ADDENDUM NO. 3

Perry Township Schools:
Southport High School Addition & Renovation Phase 1 (Activity Center Addition &
Wrestling/Center Plant Renovation)
971 E. Banta Road
Indianapolis, IN 46227

ADDENDUM NO. THREE

DATE OF ADDENDUM: February 12, 2026

C-4.4

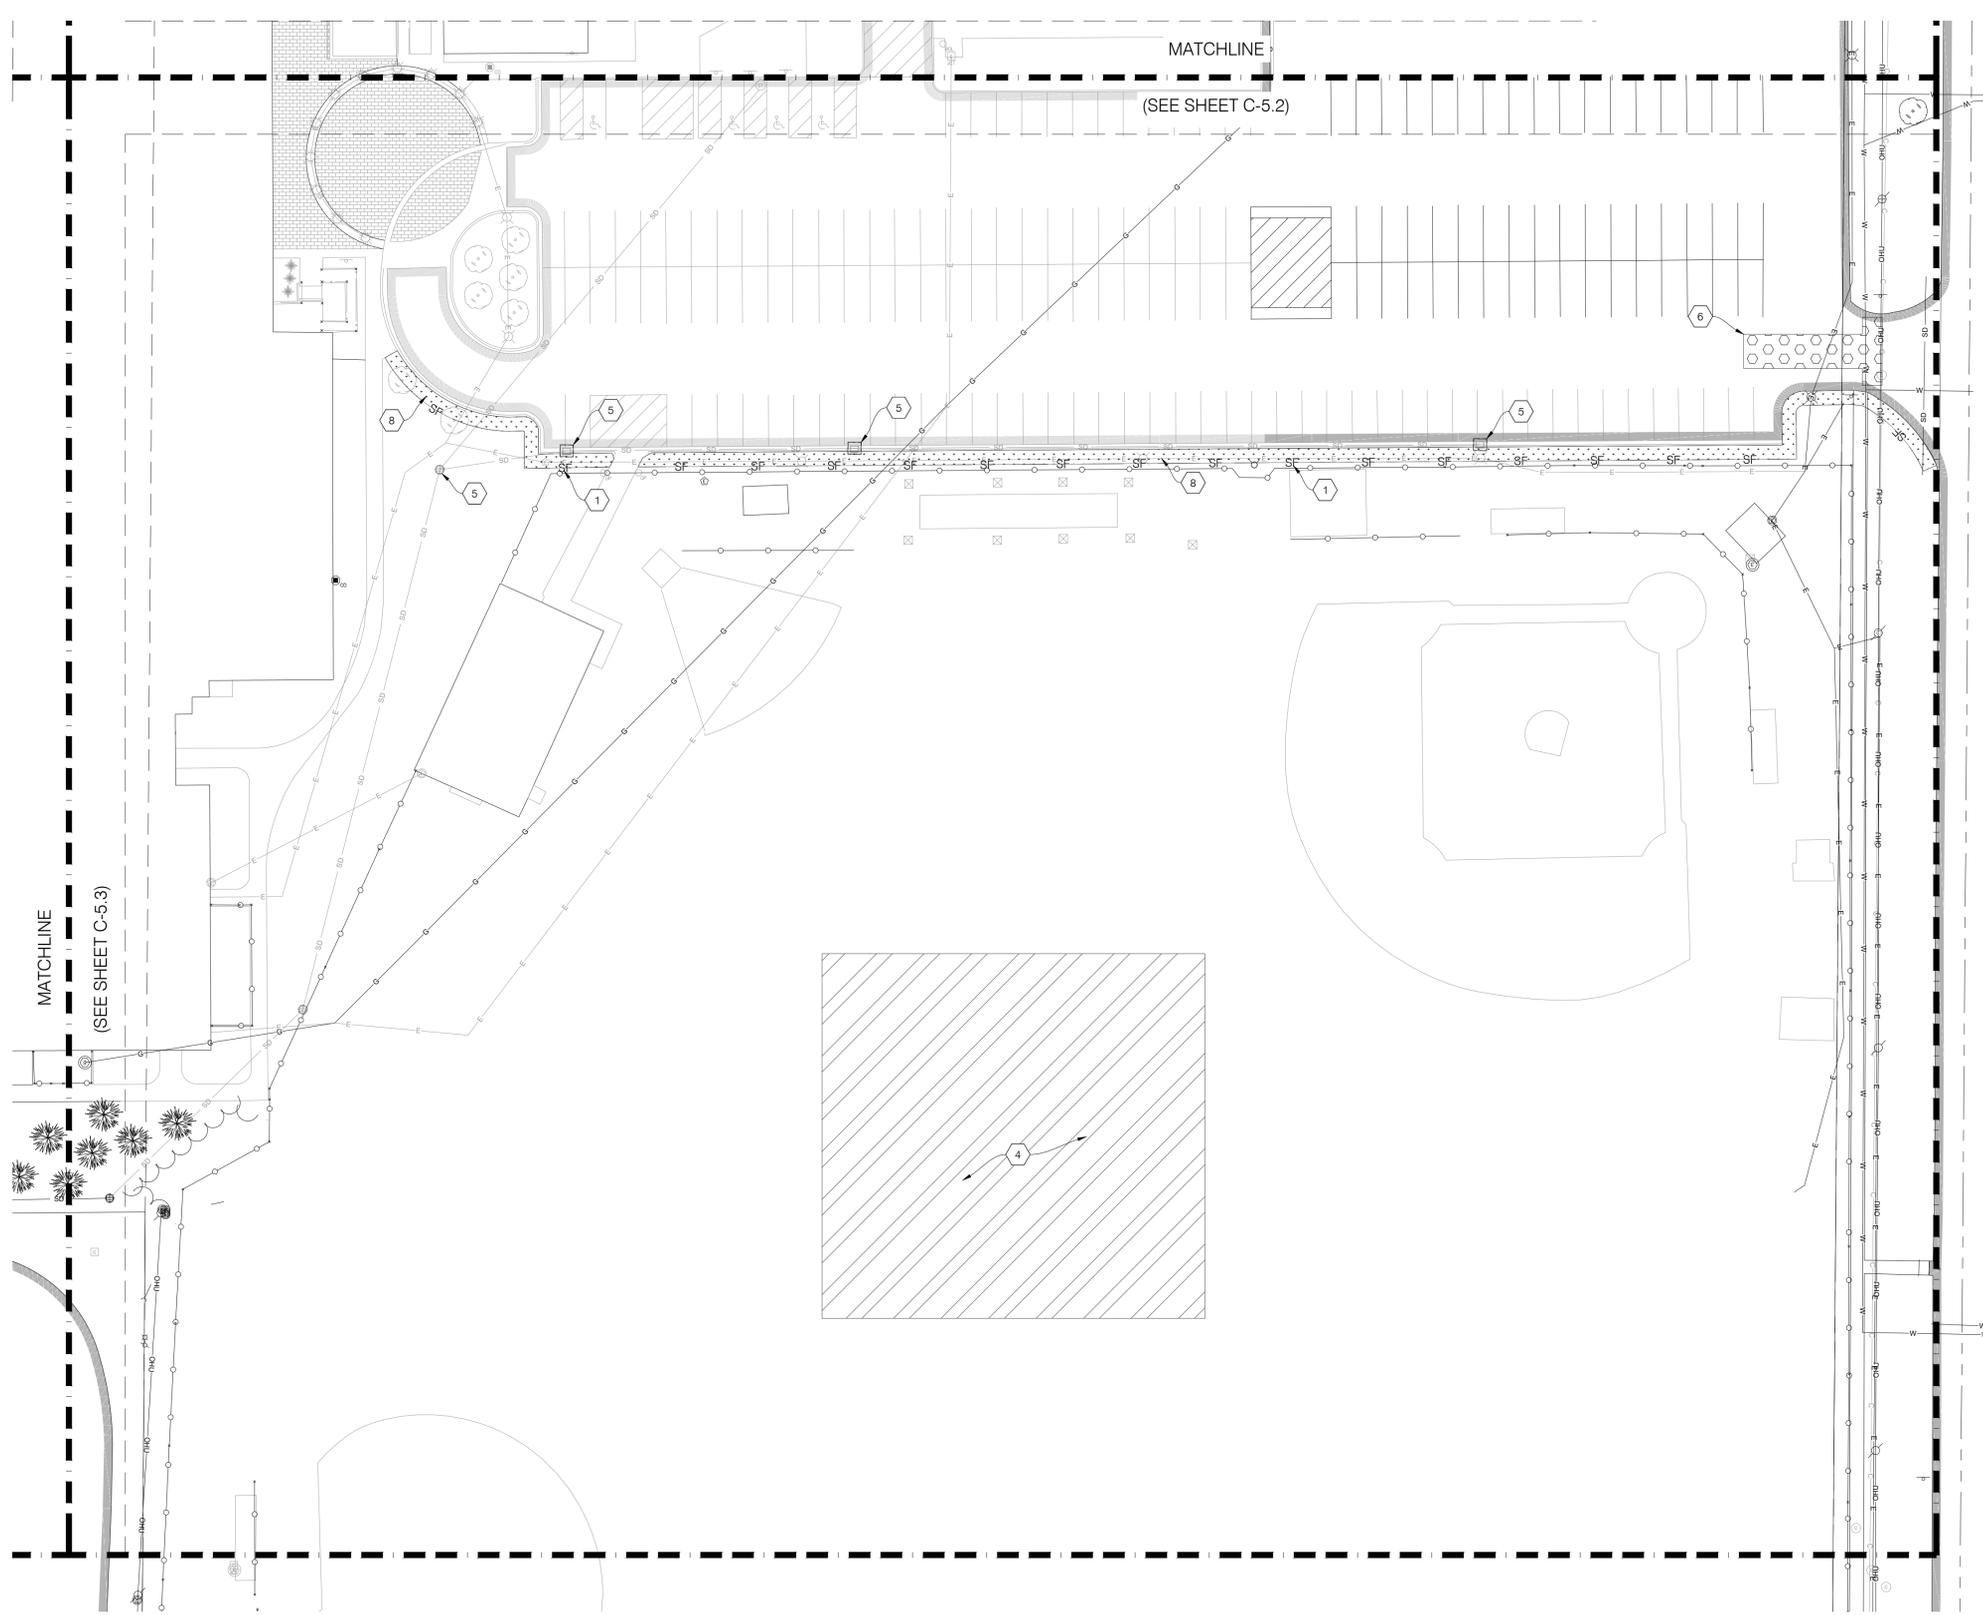
Change: Notation for extents of demolition.
 - Add demo notes to identify extent of work at softball/baseball.

SITE DETAILS

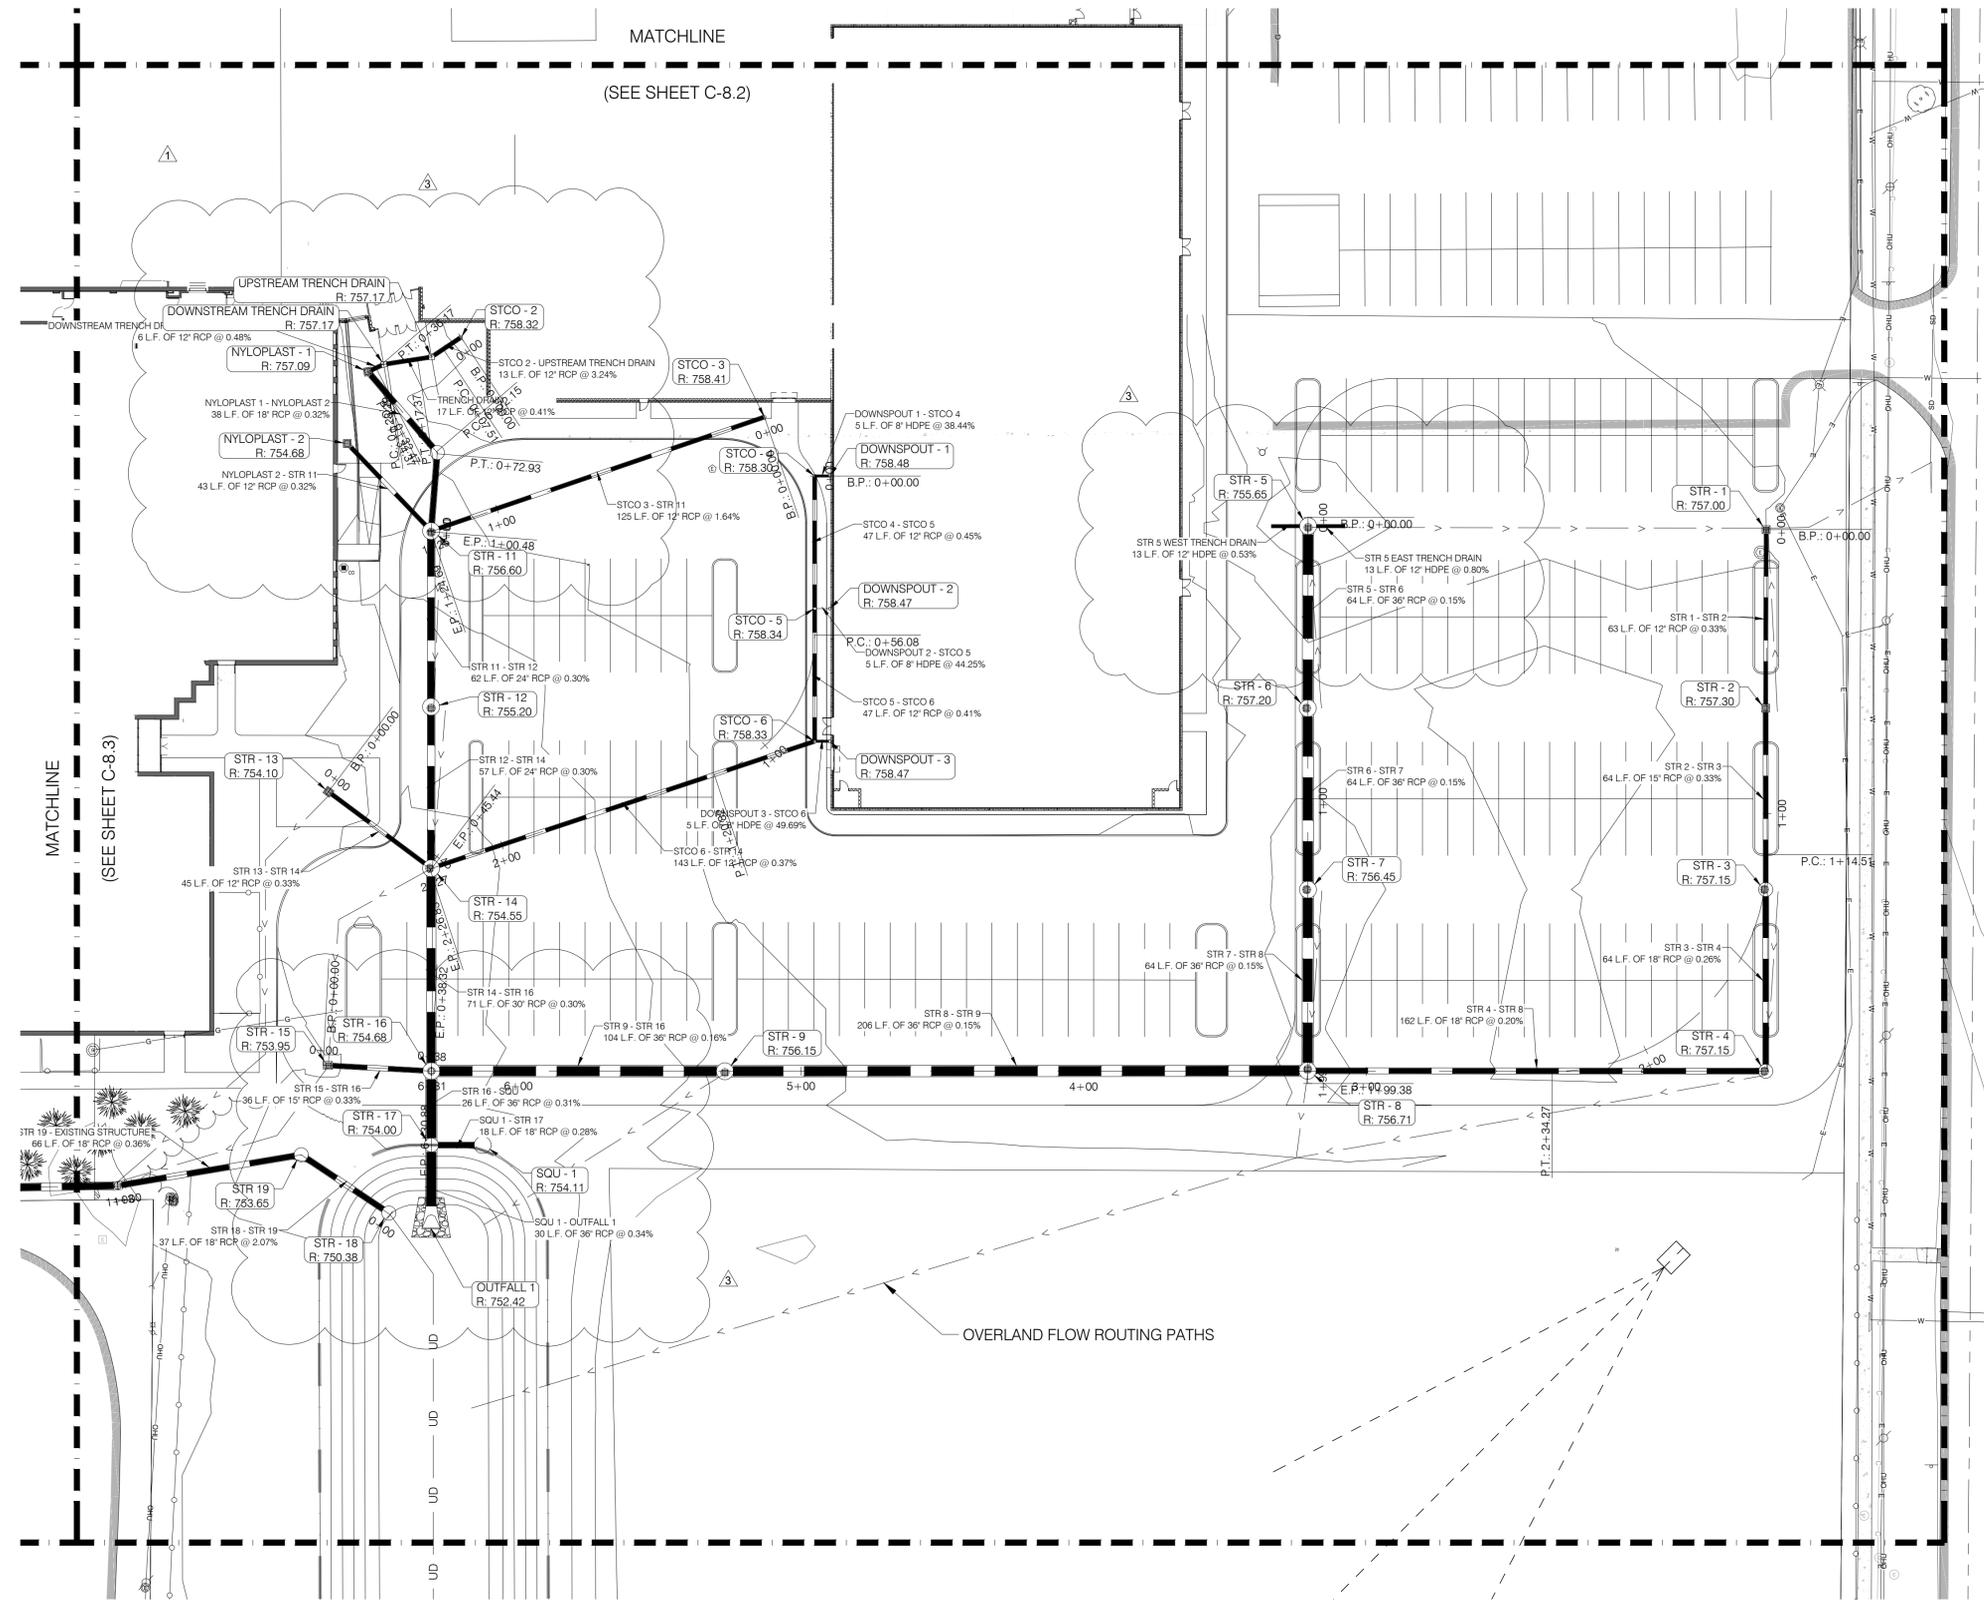
Change: Modify sidewalk details .

C-8.6

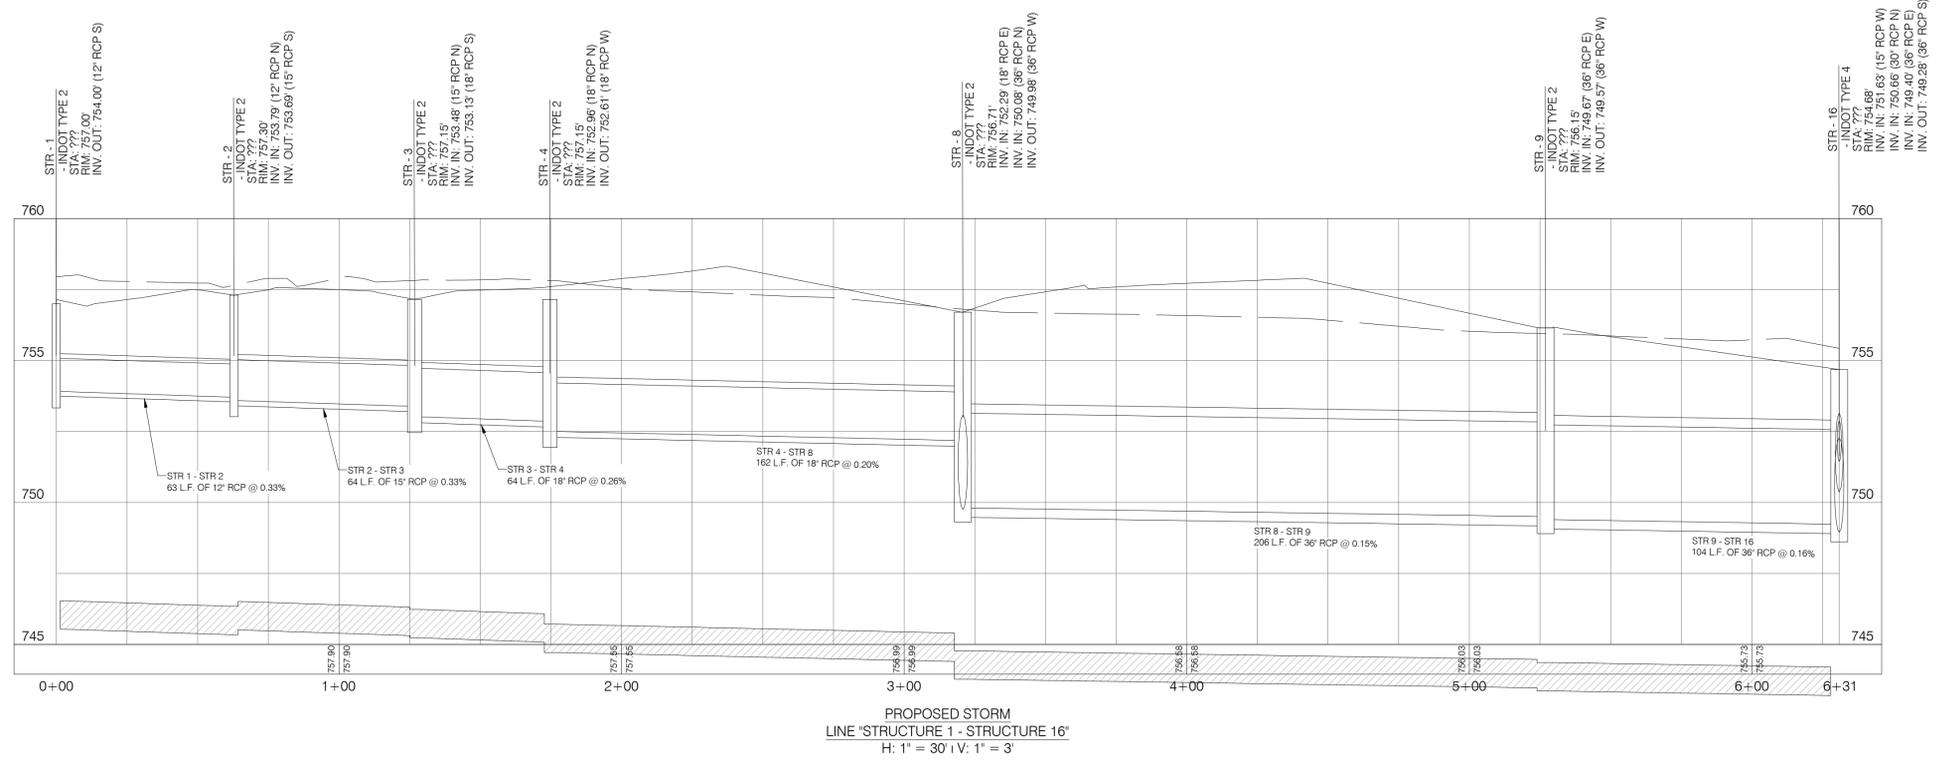
Change: Modify schedule of structures
 - See sheet for information.

C-8.8

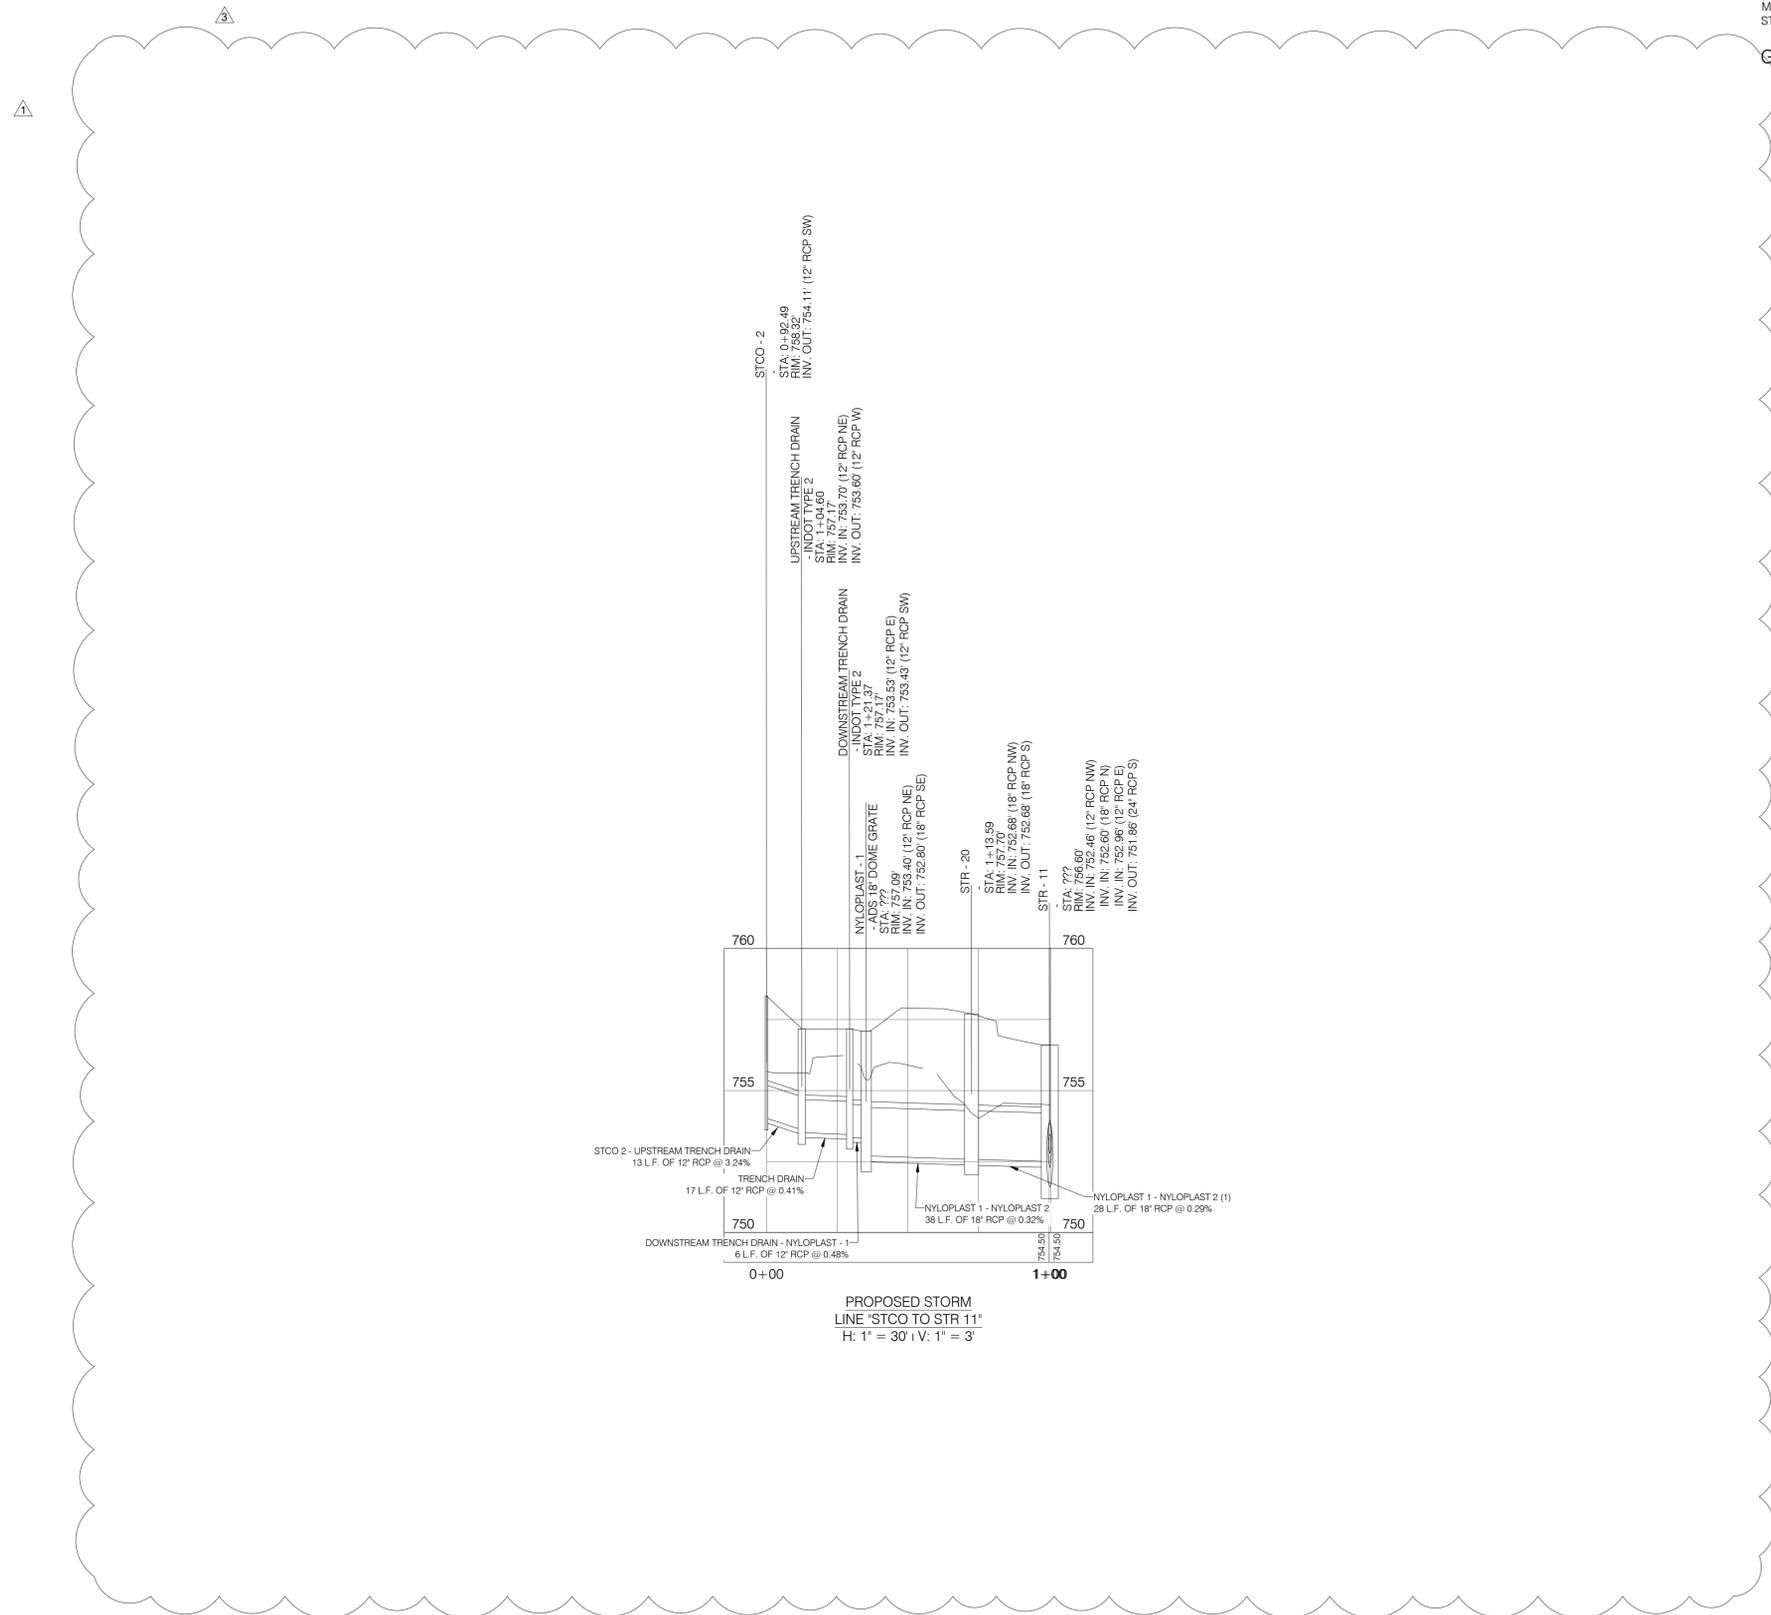
Change: Modify profile
 - Profile of structure 1.
